Re: Supplemental Submission of International
Communications Engineering, Inc. For
Inclusion In The Final Report of The
LMDS/FSS Negotiated Rulemaking Committee

**Comments on Negotiated Rule Making Committee
Document NRM94 with Regard to Test Results
Presented by NASA Lewis Research Center
and mm-Tech, Inc.**

NASA Lewis Research Center
Cleveland, OH

September 28, 1994

Figure 1 - Measured S/N ratio for C/I ratios which produce just perceptible interference for 27.5 Mbps SMSK interference at a receiver C/N ratio of 31 dB.

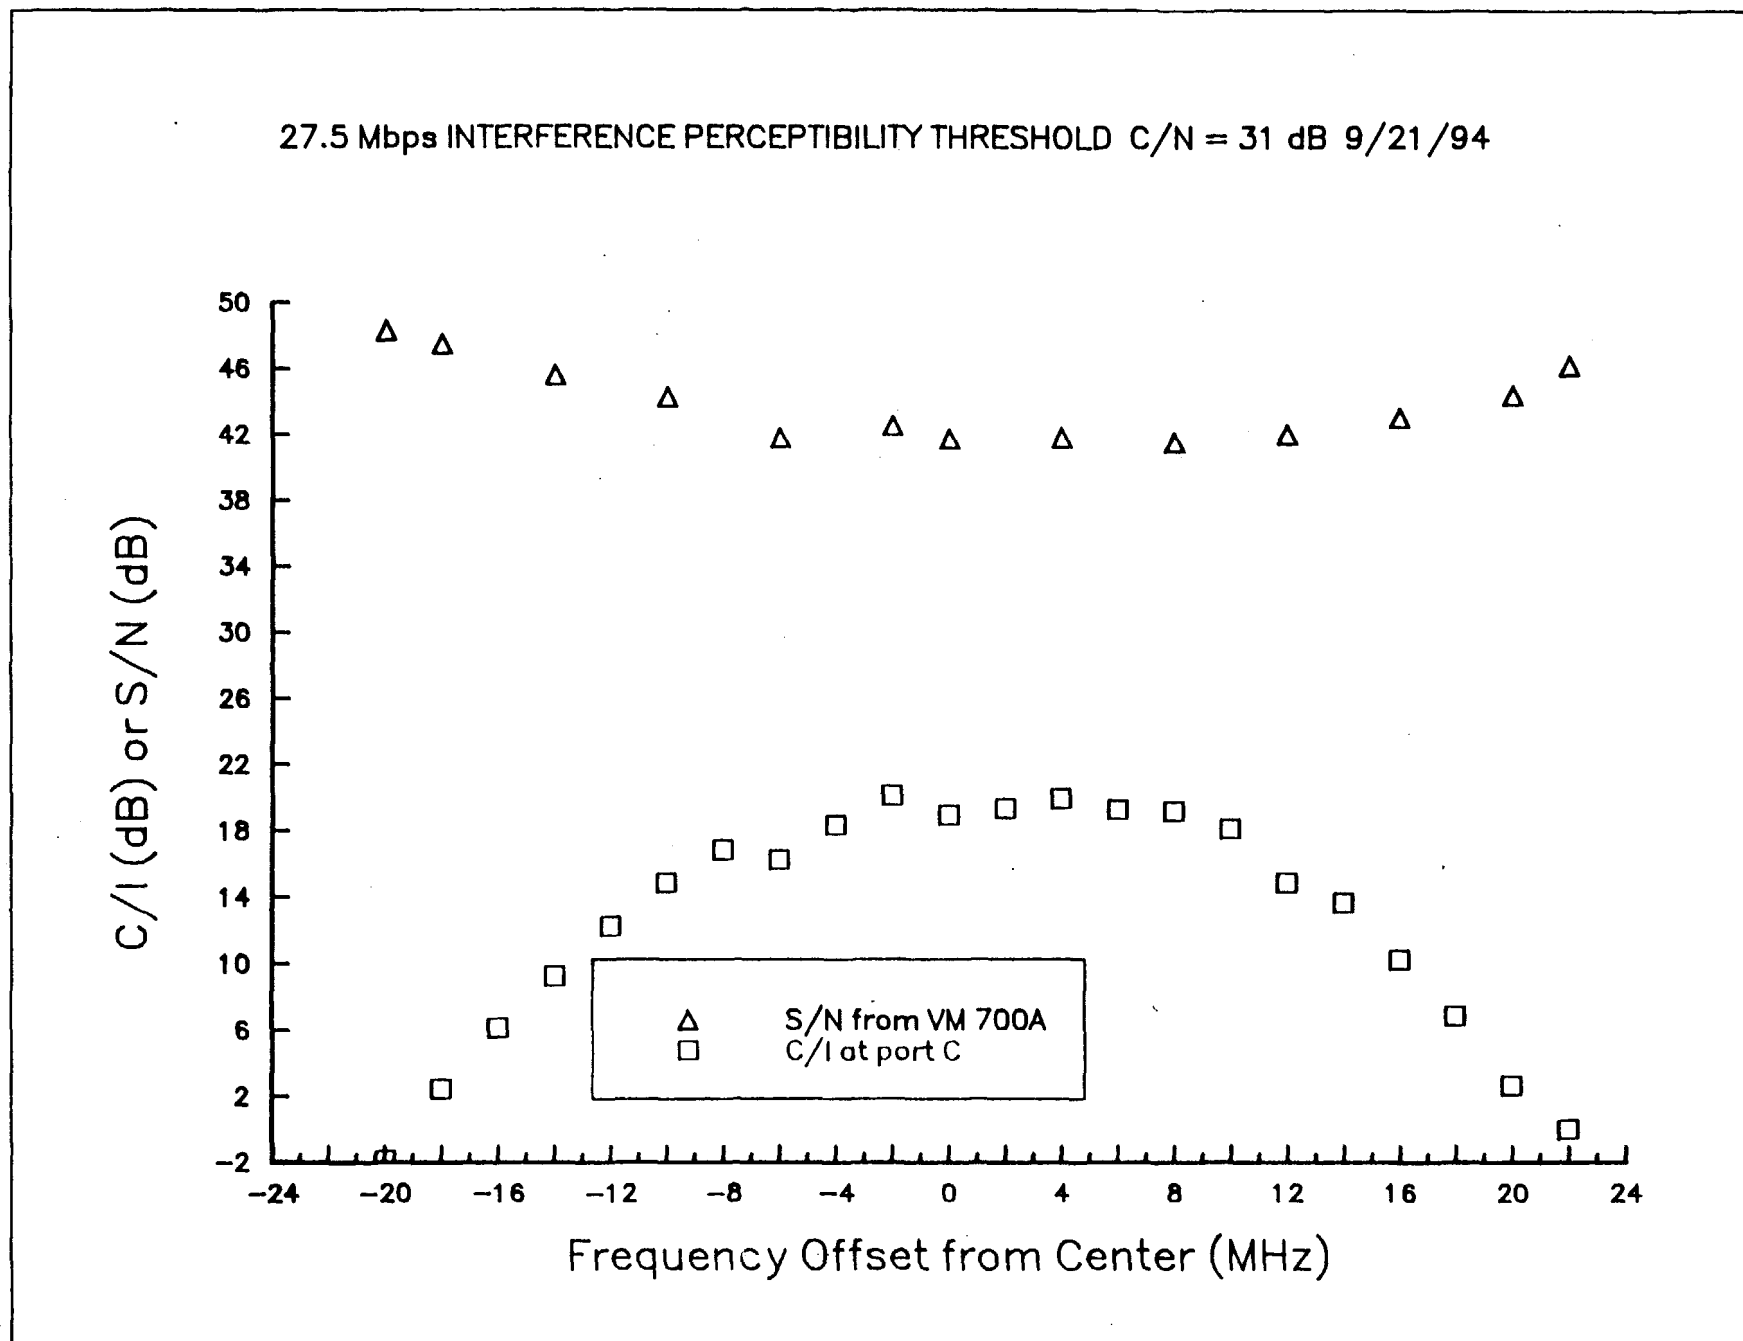
Figure 1 shows the results for a 27.5 Mbps SMSK (serial minimum shift keying modulation) interferer, as a function of the frequency offset between the center of the FM spectrum and the center of the interferer spectrum, with the received carrier-to-noise ratio (C/N), not including the interferer, set at 31 dB. The figure shows that the required C/I to produce a just perceptible degradation varies from -2 dB to +20 dB. At the same time, the measured SNR varies from approximately 41 to +48 dB.

Each of these four cases demonstrates that the measured SNR is a poor indicator of the quality of the video picture. The reason for this is the method by which the SNR is measured. In general, the measurement of video SNR is a difficult process, due to the fact that interferers affect different portions of the FM spectrum in different ways. In particular, a narrowband interferer may contribute very little to change the SNR of a video signal, but still affect a portion of the FM spectrum which produces a noticeable effect on the video picture.

Figure 2 - Measured S/N ratio for C/I ratios which produce just perceptible interference for 27.5 Mbps SMSK interference at a receiver C/N ratio of 15 dB.

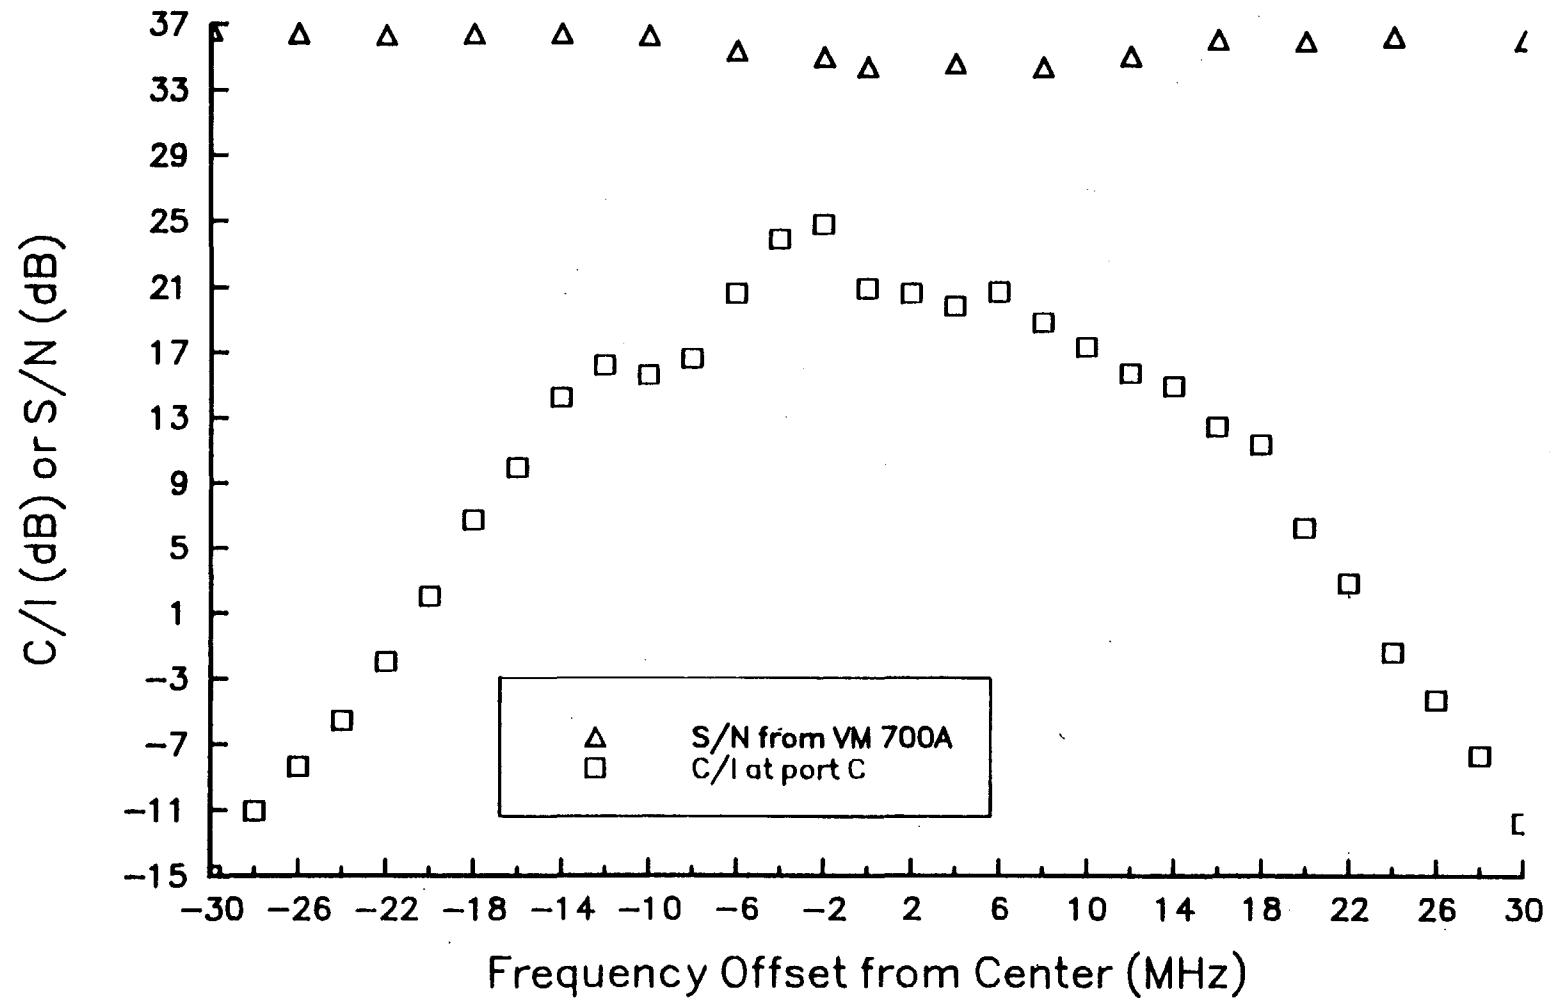
The same parameters, with the exception of the C/N, which is set to 15 dB, give the results shown in Fig. 2. The required C/I for just perceptible degradation varies from -15 to +26 dB, while the measured SNR varies from approximately 34 to 36 dB.

Figure 3 - Measured S/N ratio for C/I ratios which produce just perceptible interference for 27.5 Mbps SMSK interference bursted at 22.5 % duty cycle, at a receiver C/N ratio of 31 dB.

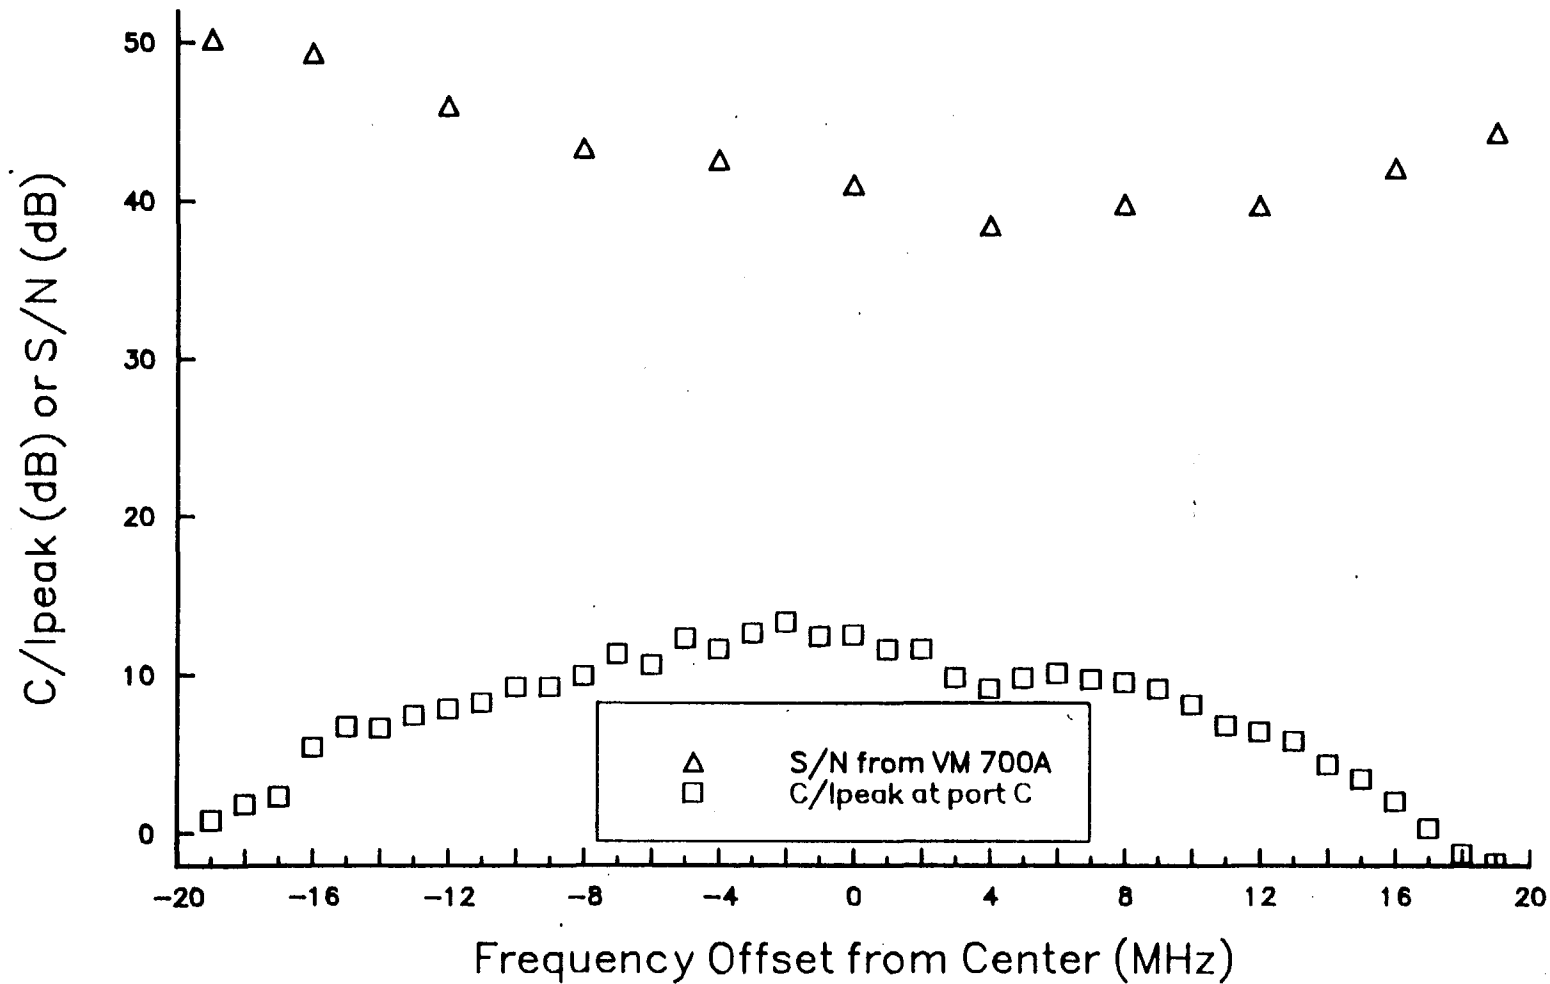
In figure 3, the results shown are for a 27.5 Mbps SMSK signal bursted at a 22.5% duty cycle. The C/I (measured as the peak C/I rather than time-averaged C/I) varies from -2 to +14 dB in order to produce a perceptible degradation. The corresponding measured SNR varies from approximately 38 to 50 dB.

Figure 4 - Measured S/N ratio for C/I ratios which produce just perceptible interference for 1.544 Mbps (T1) QPSK interference at a receiver C/N ratio of 31 dB.

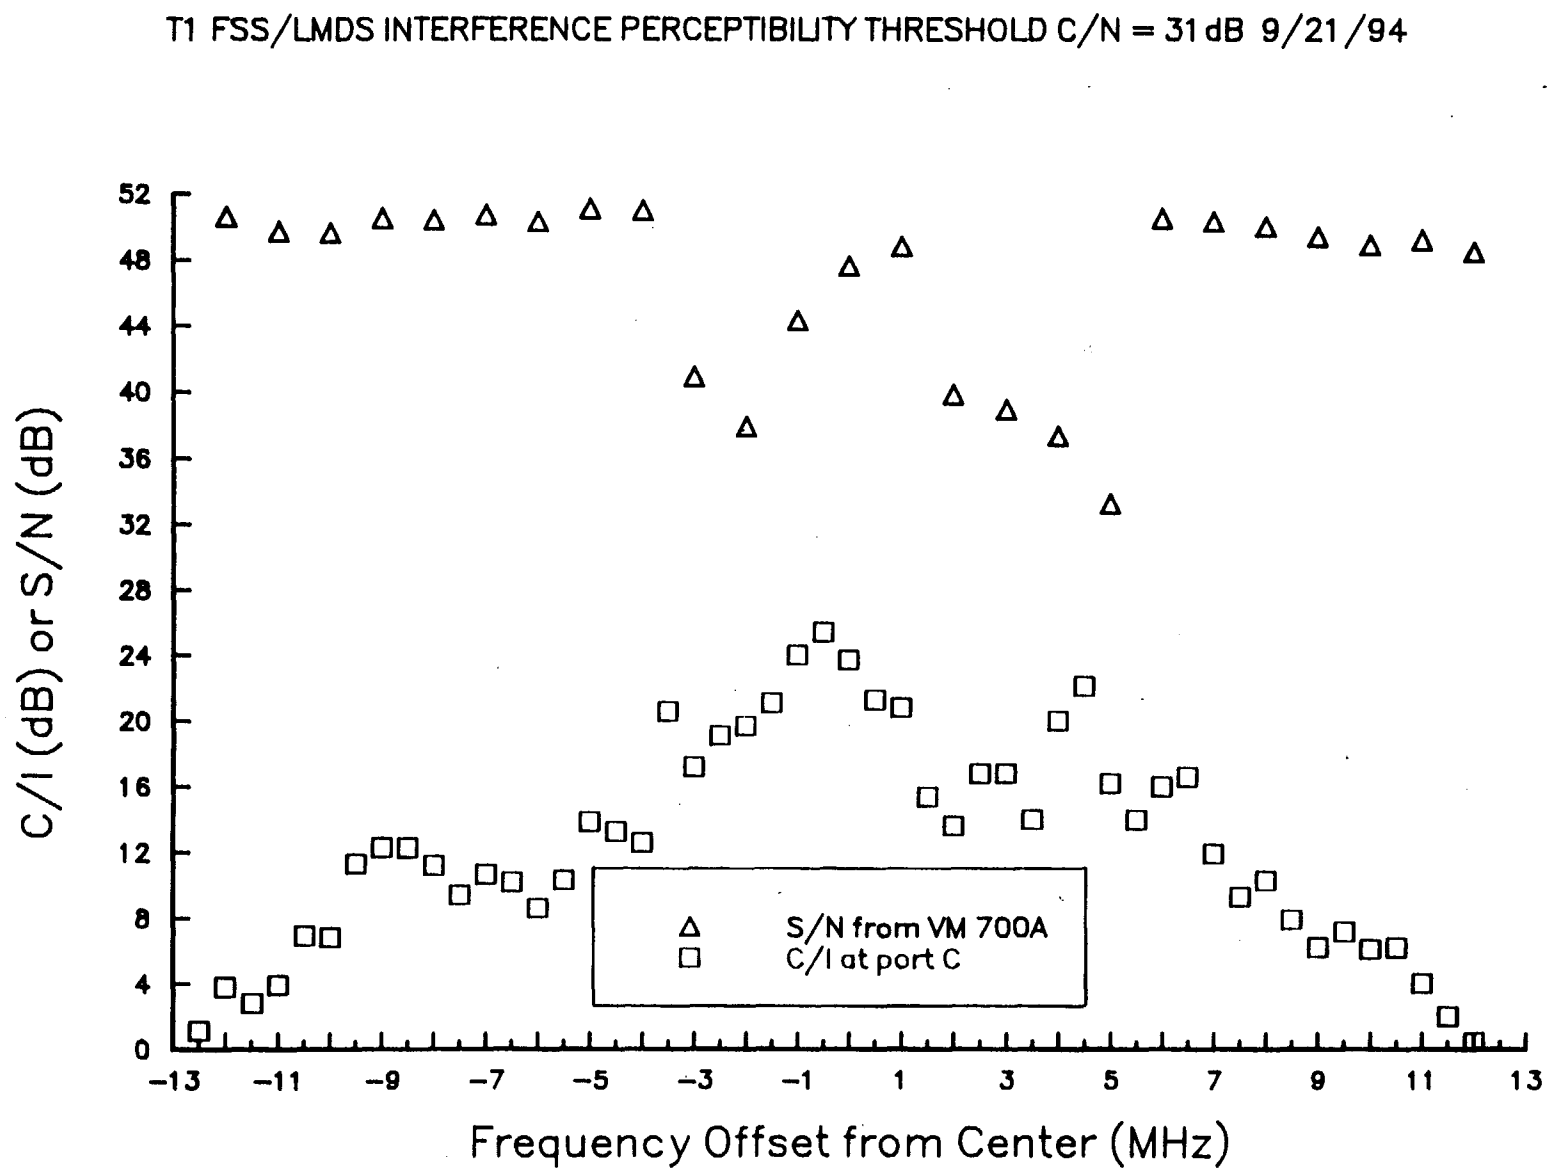
The fourth measurement is for a single narrowband T1 continuous QPSK signal (1.544 Mbps). The results, shown in Fig. 4, indicate a variation of the C/I required to produce just perceptible degradation of 0 to +25 dB. The corresponding measured SNR varies over the range 33 to 51 dB.
